Technical Information TM 315-20

GROB G 103 "TWIN II"

GROB G 103 A "TWIN II ACRO"

Subject : Inspection and exchange of the slide at the front pedal unit.

Picture 1 :

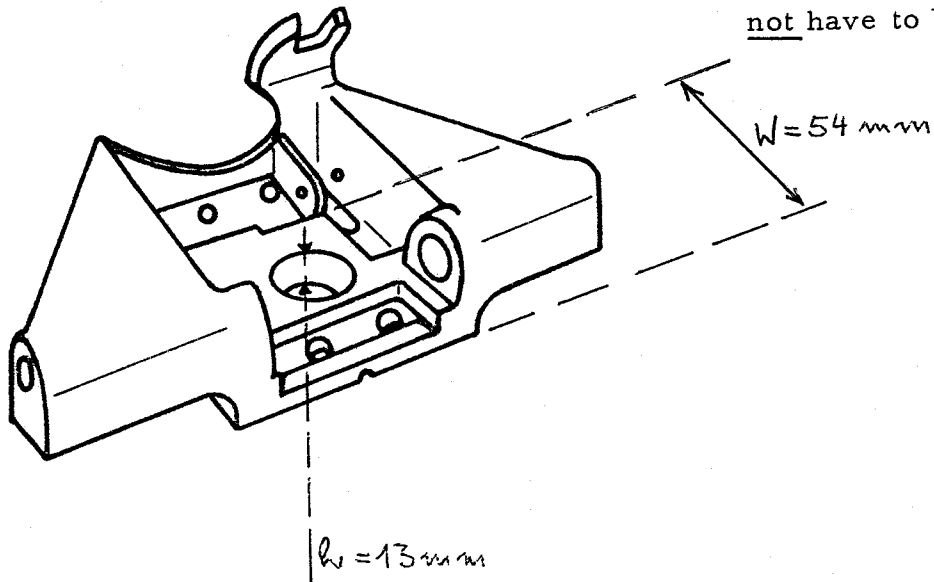
Instructions : Instruction 1 :  
Inspection of the slide at the front pedal unit before next start. If the slide no. 103B-4208.10 (picture 1) with the wide, high cross-web is installed, there is no reason for reclamation. Instructions 1 and 2 are not applicable.

This slide with wide, high cross-web is safe and does not have to be exchanged.

Instruction 3 :  
The slide no. 103-4208.10 (picture 2) has to be exchanged against slide no. 103B-4208.10 (picture 1) not later than October 31, 1982. The necessary material for this purpose (see below) has to be ordered from the manufacturer with the attached order form and it has to be proceeded according
